2	11/26/25	ADD SCD RM-3.1

BRIDGE NO. CUY-77-15.46
IR 77 OVER WOODLAND AVE.

ESTIMATED QUANTITIES
BRIDGE NO. CUY-77-15.46
IR 77 OVER WOODLAND AVE.

GENERAL PLAN
BRIDGE NO. CUY-77-15.62
IR 77 OVER E. 22ND ST.

E. 14th ST.
FORWARD LEFT

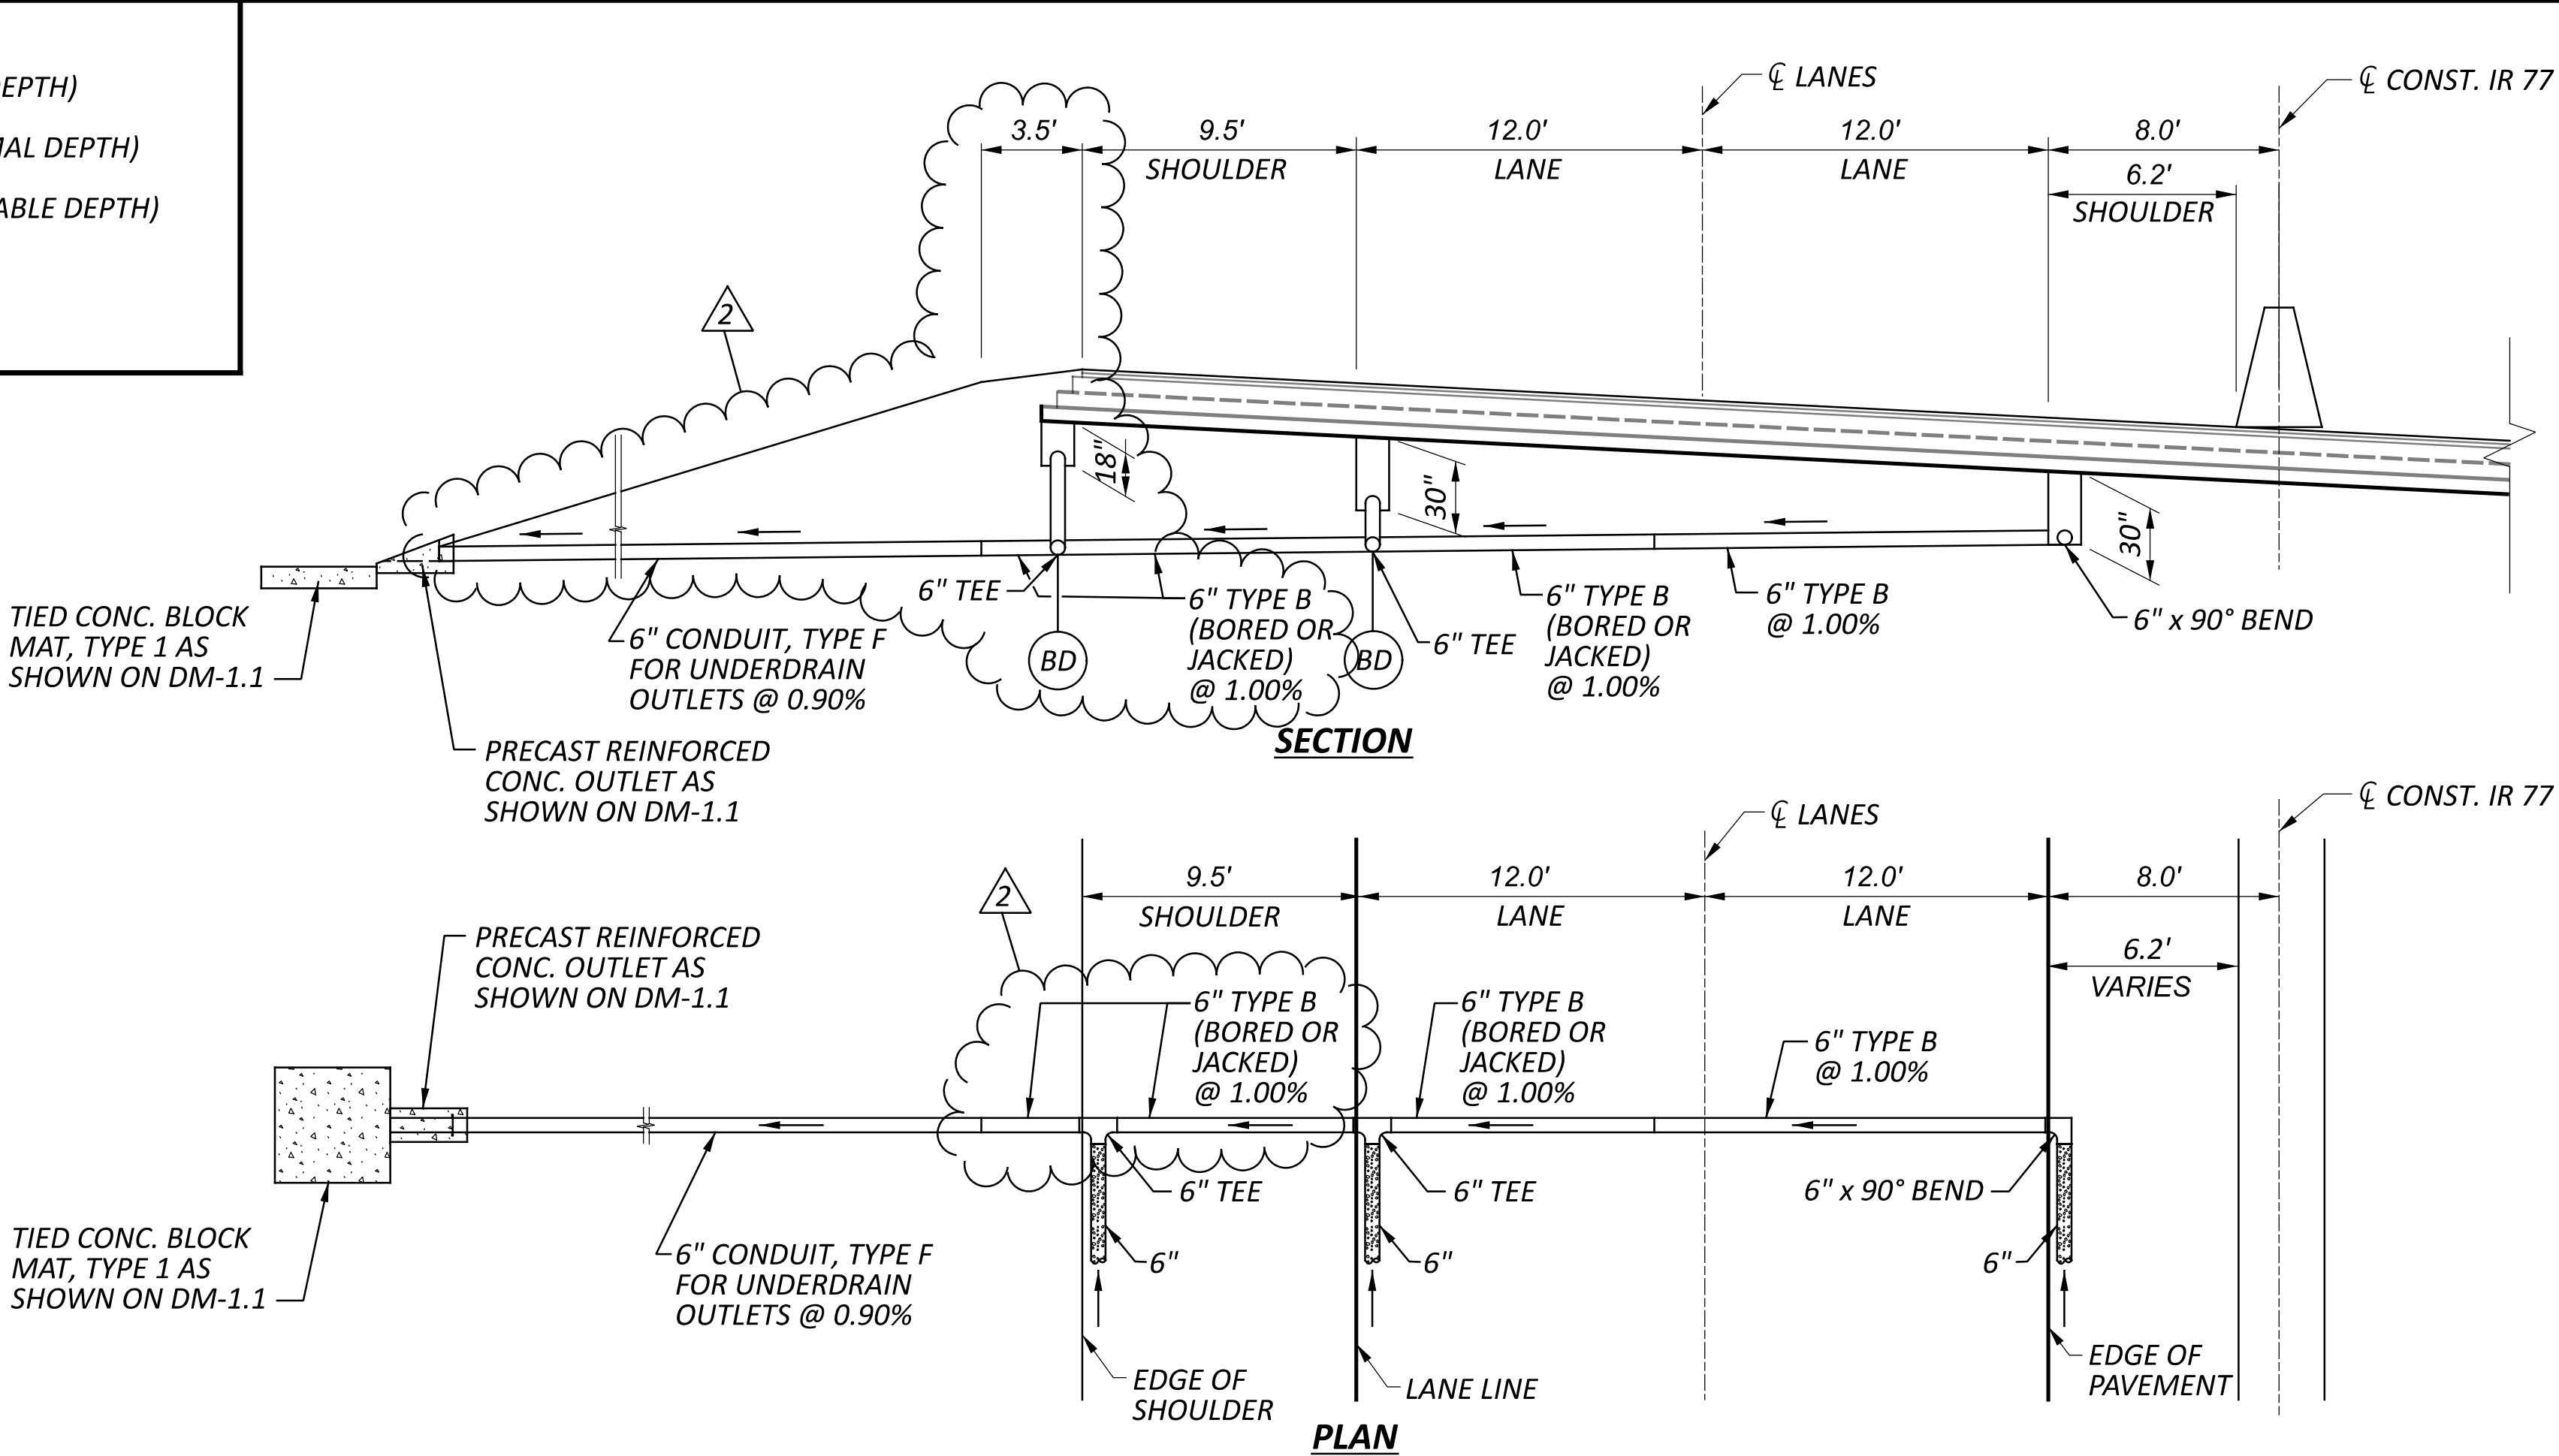
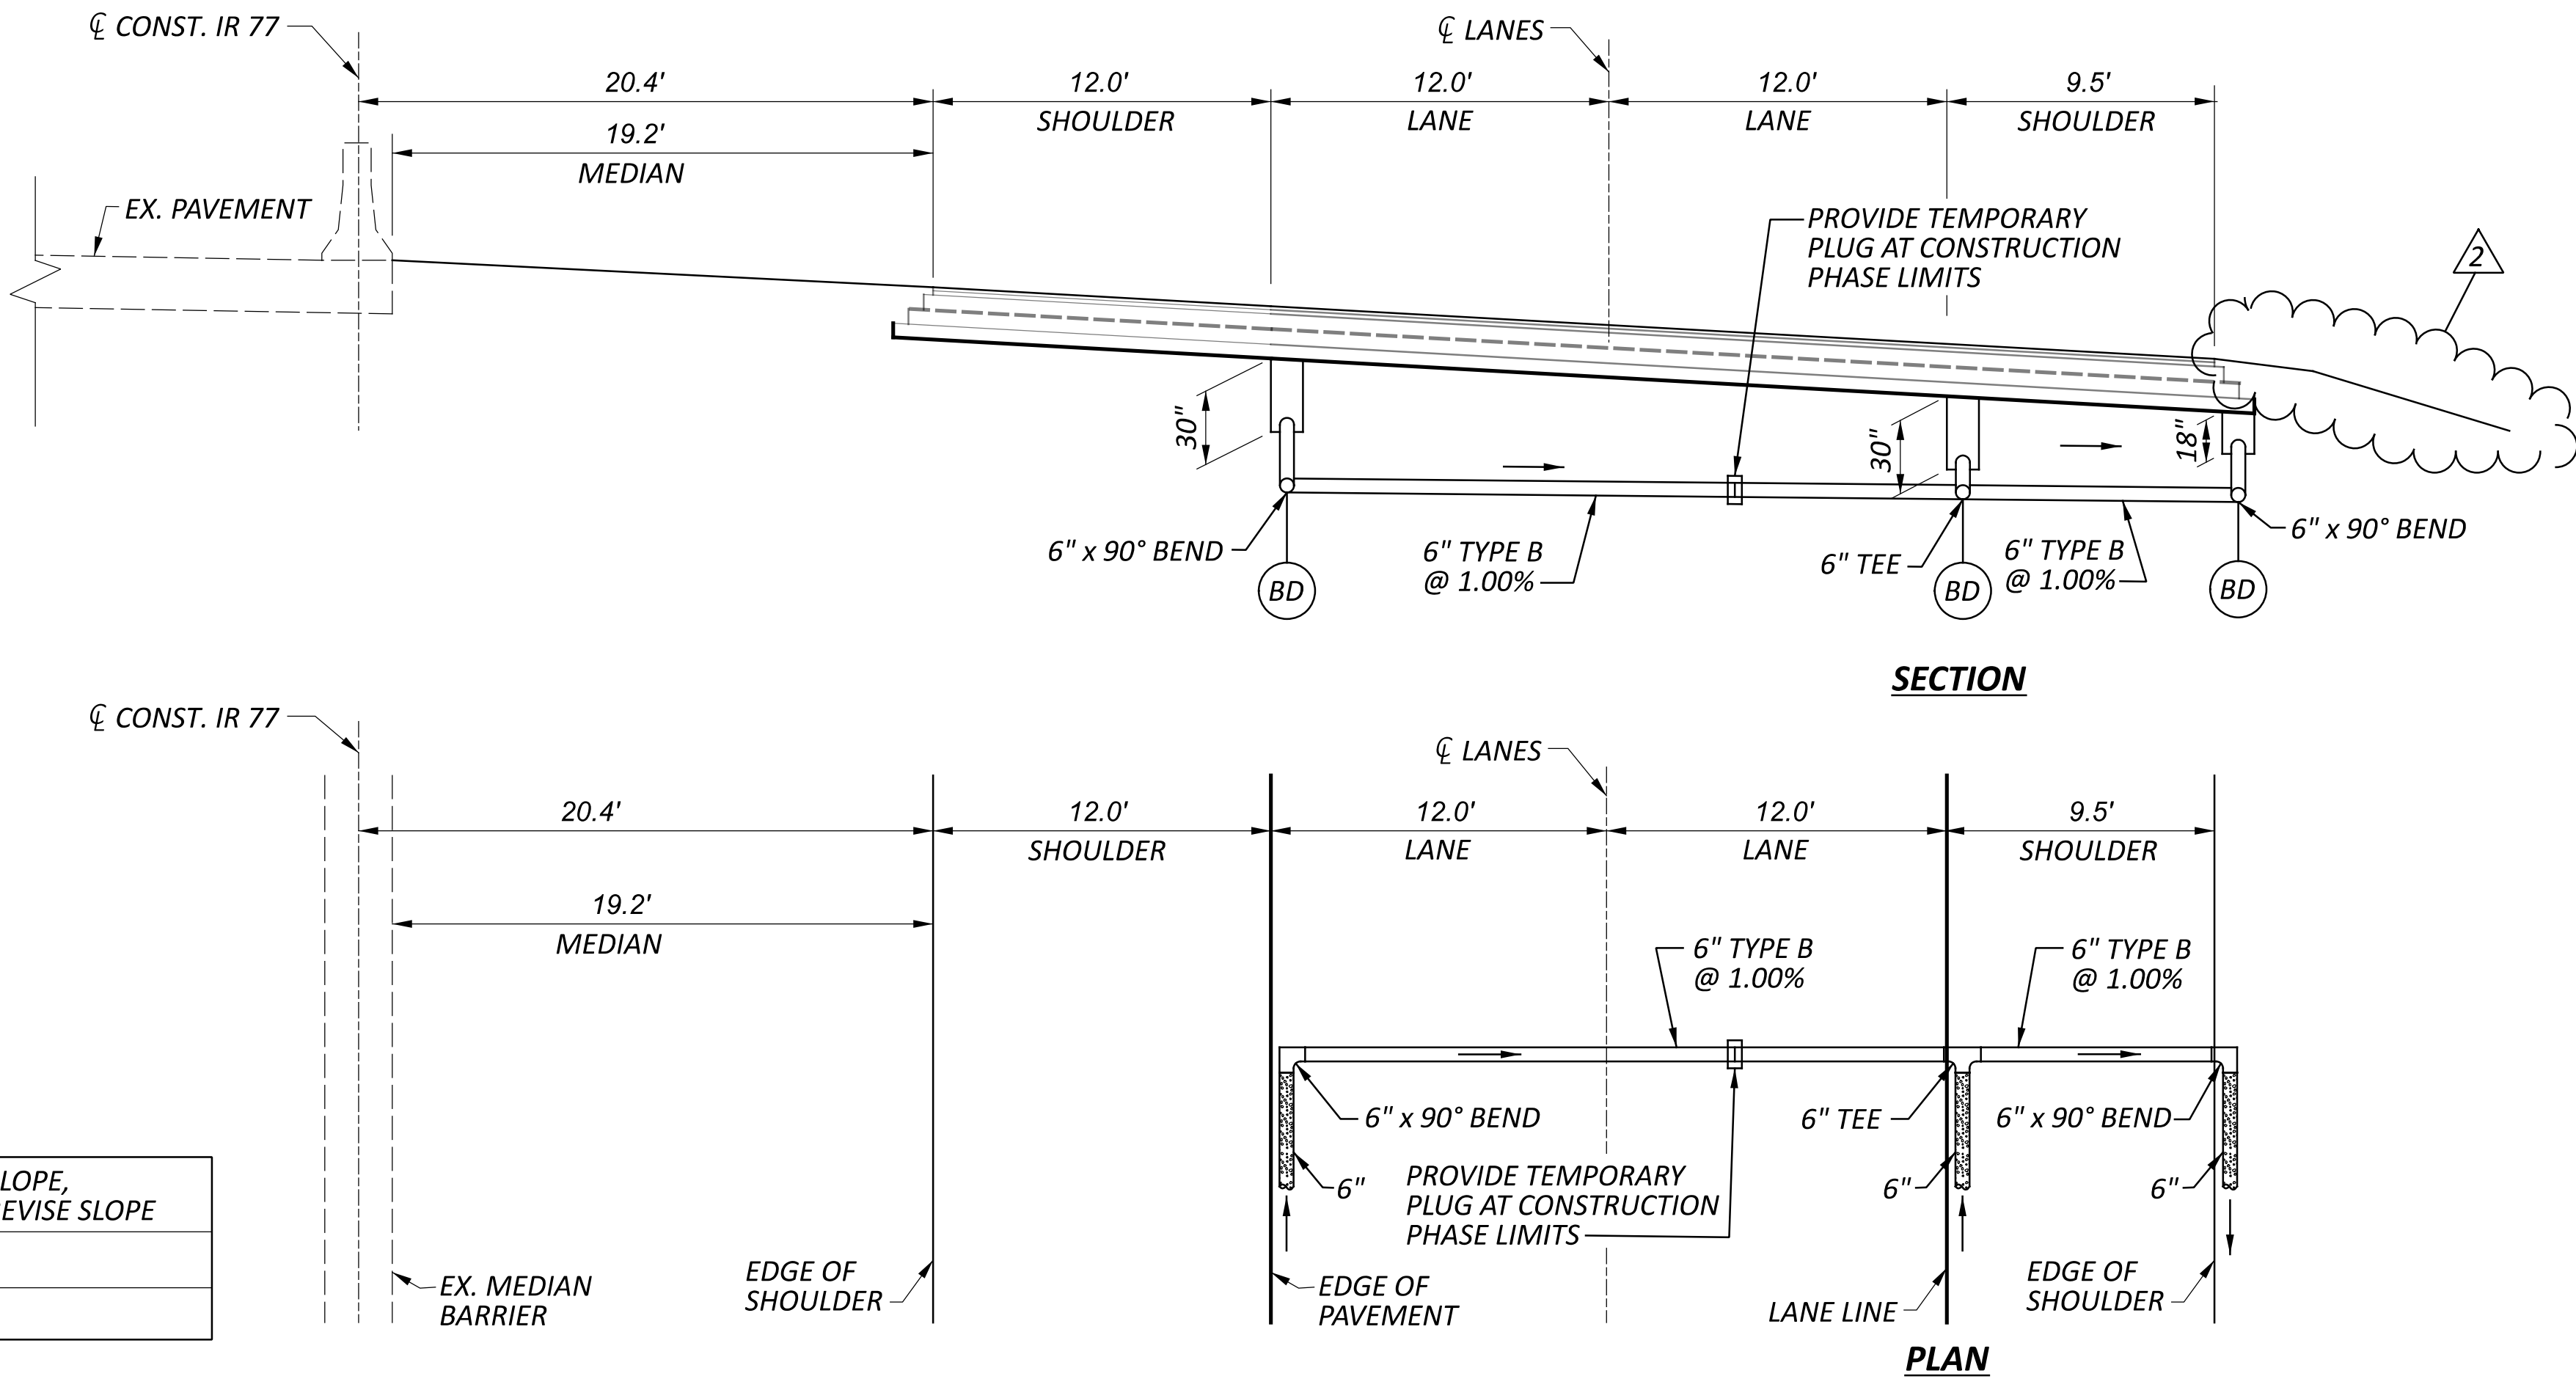
2	11/26/25	REVISE UD OUTLET SLOPE, 6" TYPE B LENGTH, REVISE SLOPE
